# THE FIRST CHURCH OF CHRIST, SCIENCE

## **Proposed Accessible Entry BLC Hearing**

September 28, 2021

# BLC Suggestions

**Suggestion A**

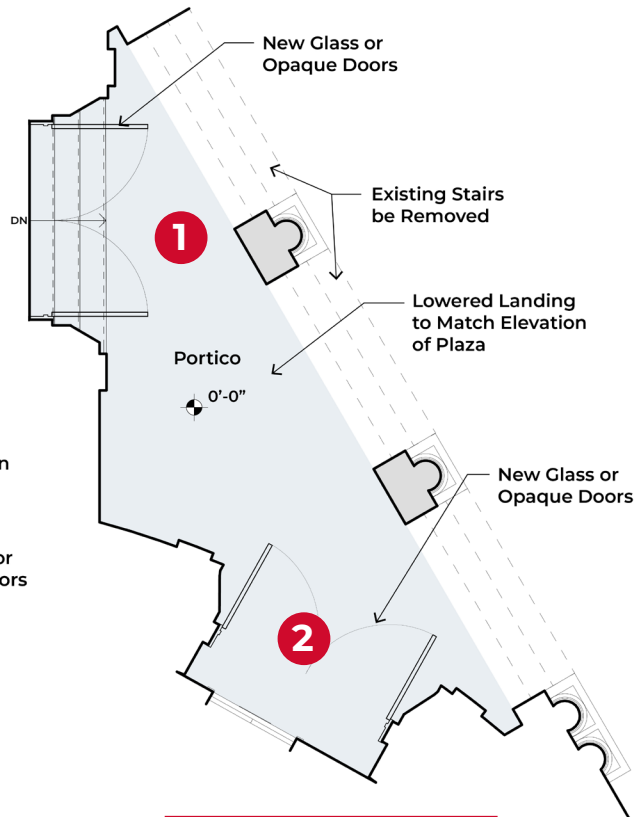
**1 Lower Entire Portico:**  
Lowering the portico and placing stairs directly adjacent to the egress doors without a landing is not code compliant.

- Lowering the portico and placing stairs directly adjacent to the egress doors without a landing is not code compliant.
- Suggested glass doors just in front of elevator doors do not provide required clearances and is not code compliant.
- Exterior exposed elevator is not recommended by elevator expert consultant.
- New vestibule would require permanent alterations to the existing stone facade detail.

**Suggestion B**

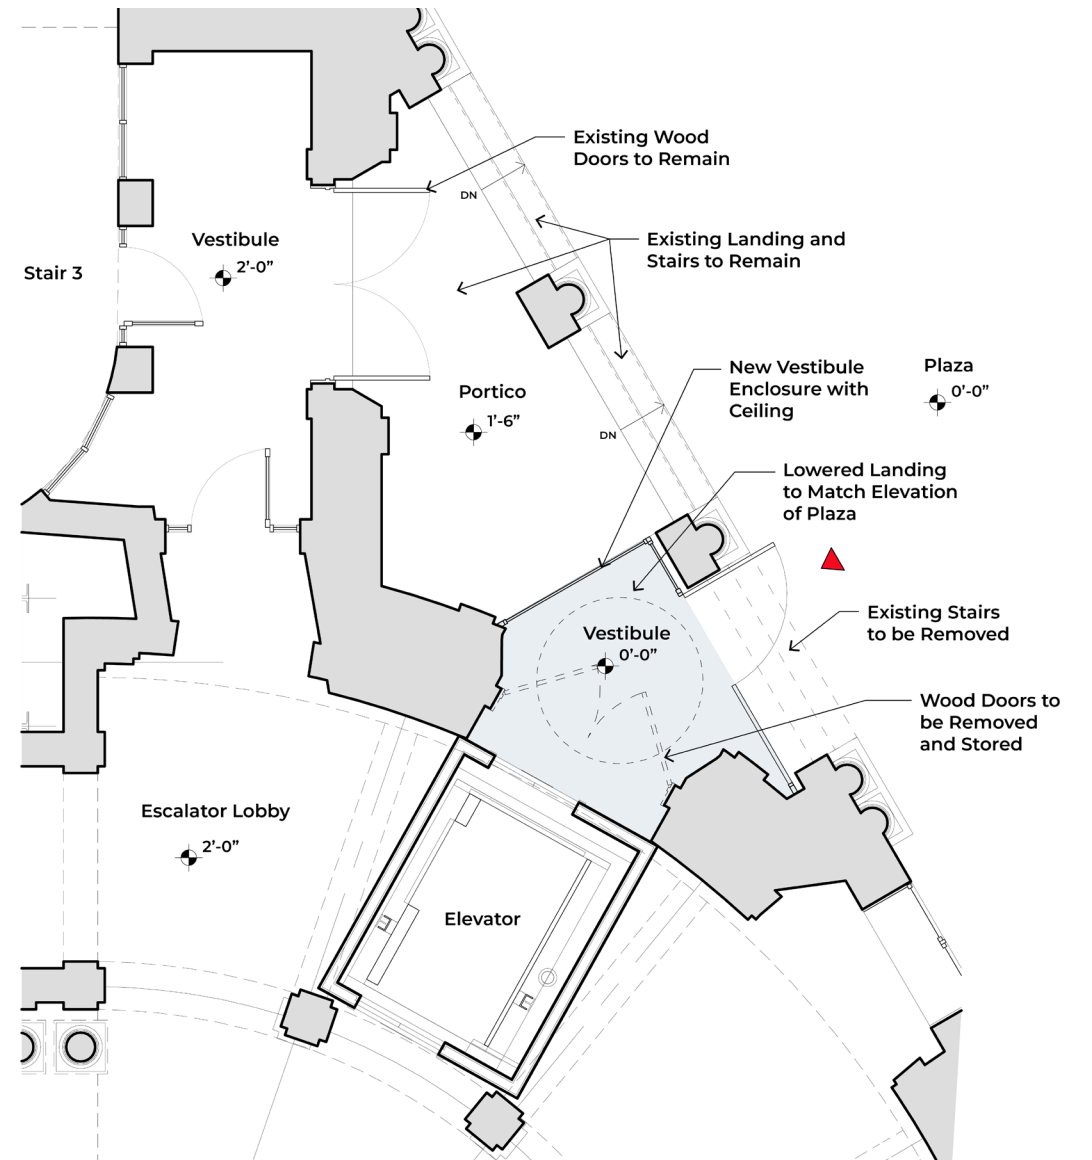
**2 Add Doors in Front of Elevator:**  
Doors located at an accessible entrance must comply with code and be located 48" min from the elevator doors. Given the geometry of the portico, this is not feasible.

Frame Attachments to Existing Stone  
Required Adjustments

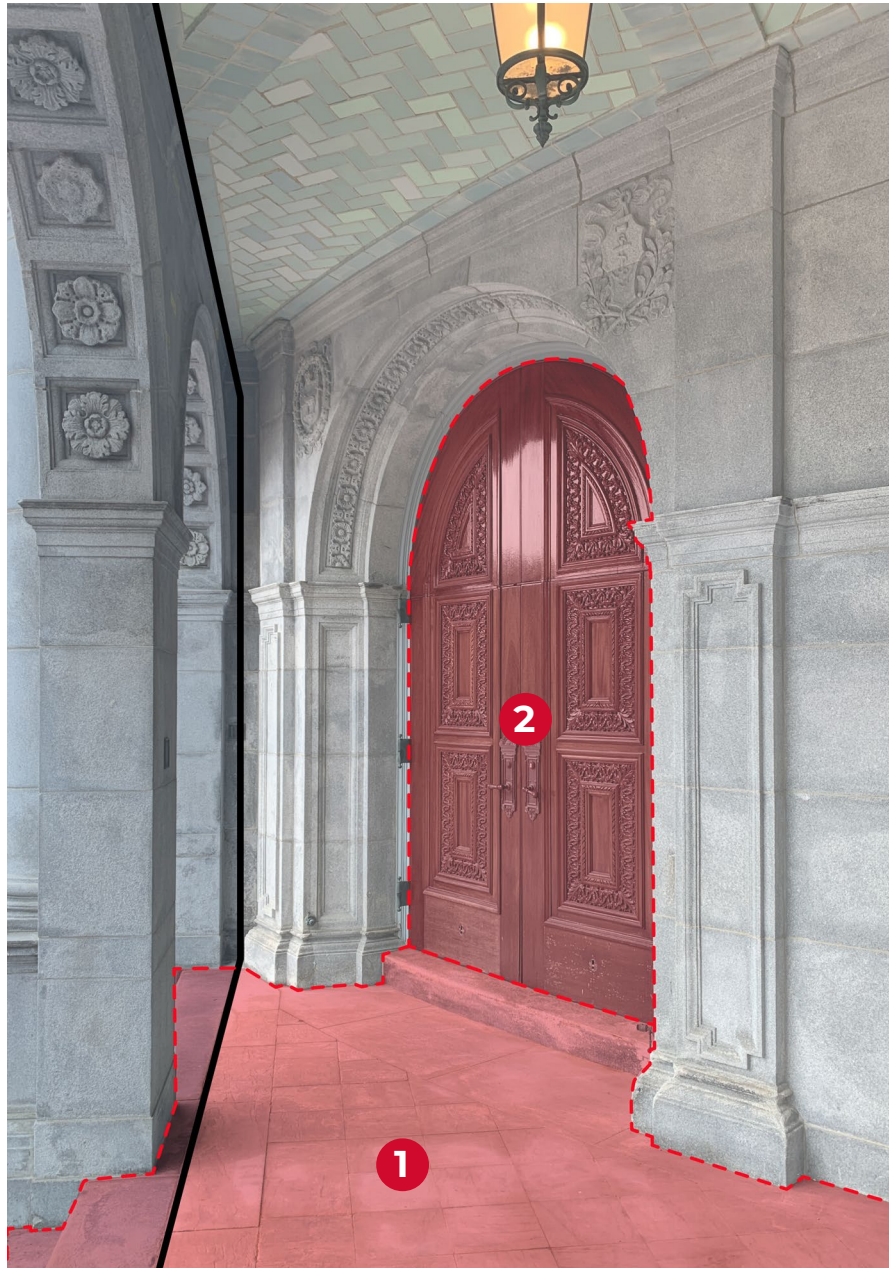
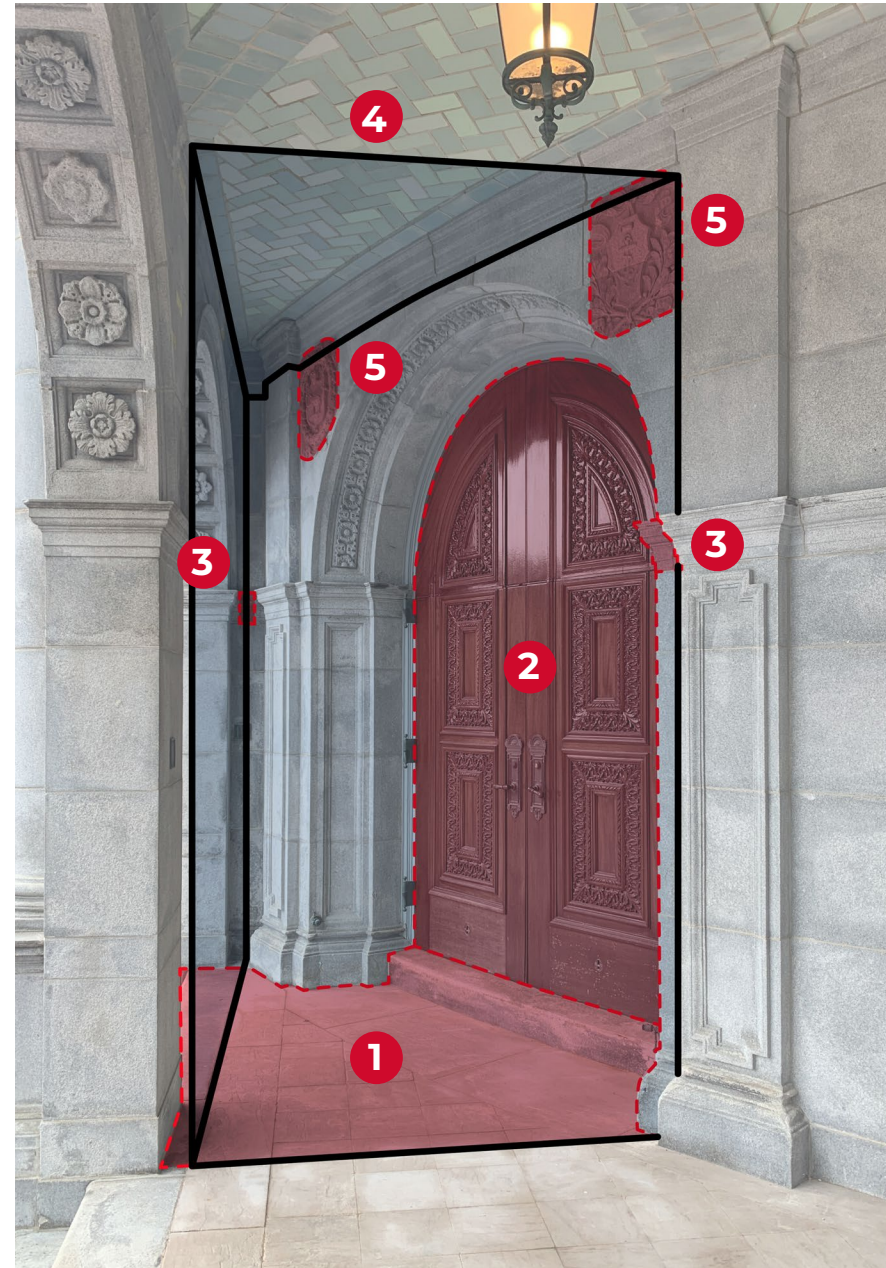
- 1 Portico landing to be lowered to match the elevation of the plaza.
- 2 Existing wood doors to be removed and stored.
- 3 Section of capital would need to be removed for vestibule attachment.
- 4 Arched Guastavino tiled ceiling to remain as existing.
- 5 Medallions carved into the stone would need to be removed.
